# LIST OF OVERHAUL MODIFICATIONS

## EXPEDITOR

# MAGNETIC PARTICLE INSPECTION (MPI) AND SPAR REPAIR AND REINFORCEMENT

## WIRE STRINGER REINFORCEMENT

Figure 1

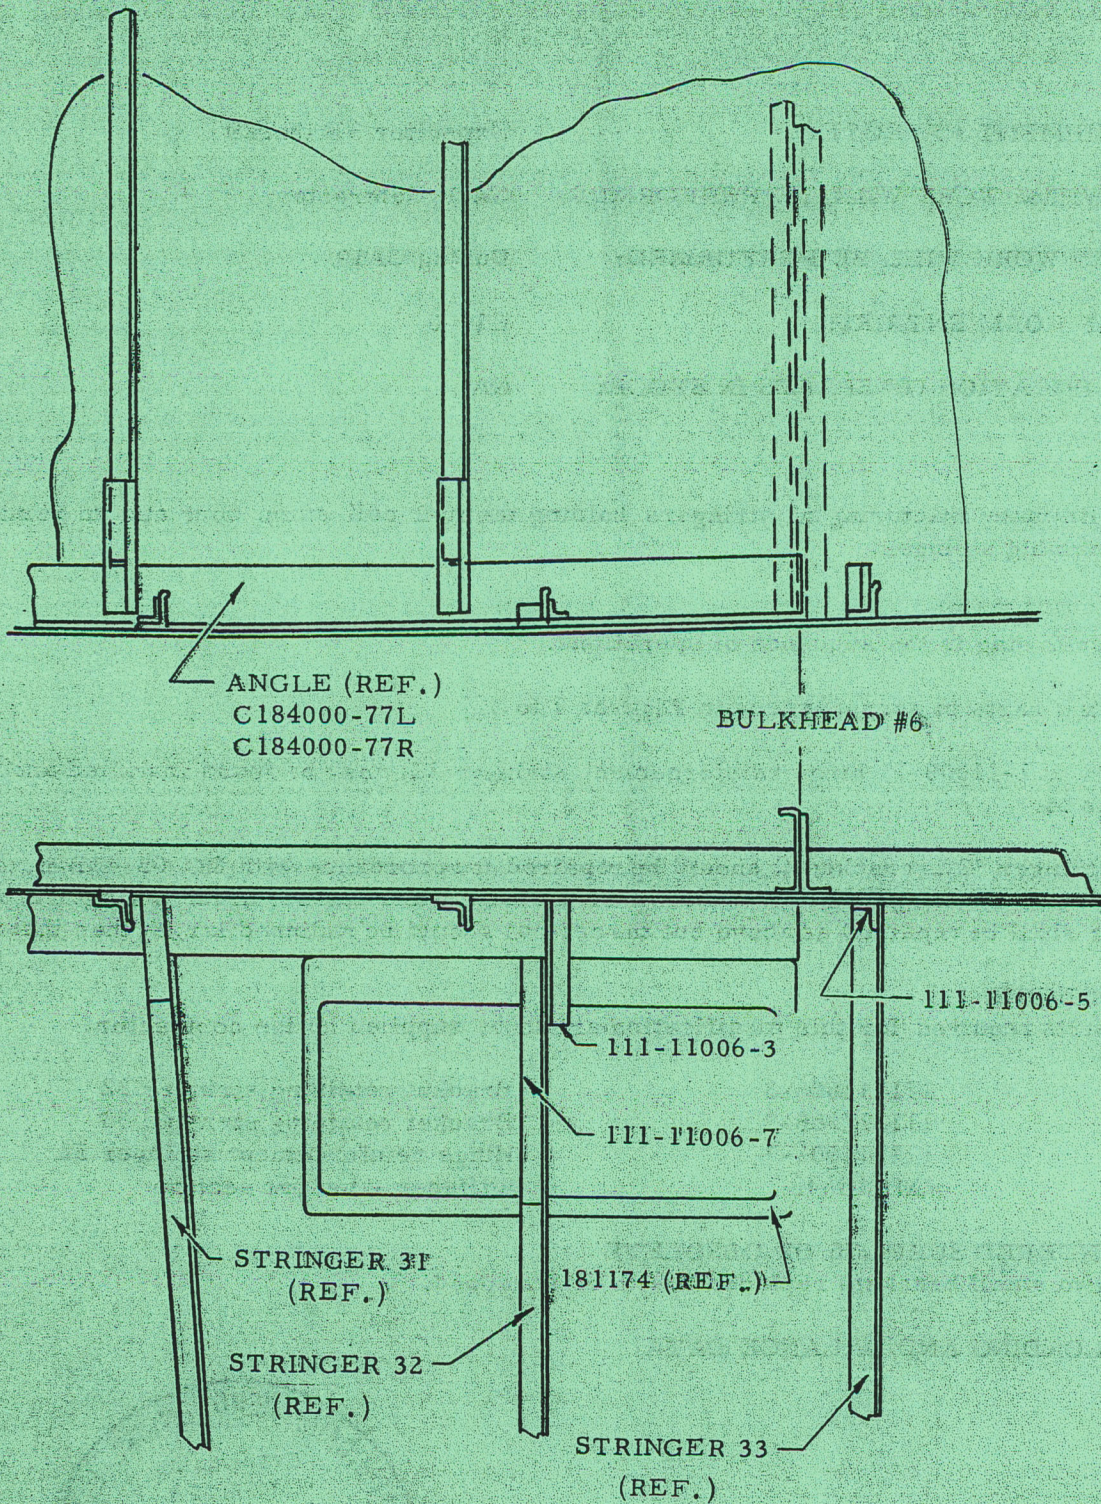
1 To eliminate fracturing of stringers holding the fuel cell sump door and to reinforce the bracket retaining stringer.

- (a) Install parts in accordance with Figures 1 to 4.
- (b) Part 111-11006-7, hinge reinforcement stringer 32, may be found installed and if so, is to be left as is.
- (c) If stringer 32 is cracked it should be repaired in accordance with EO 05-45B-3, Appendix A10, using replacement part given in Part 8 of the EO. If the cut-out in the stringer is cracked, the stringer shall be repaired as above but the cut-out should be radiused larger than that existing.
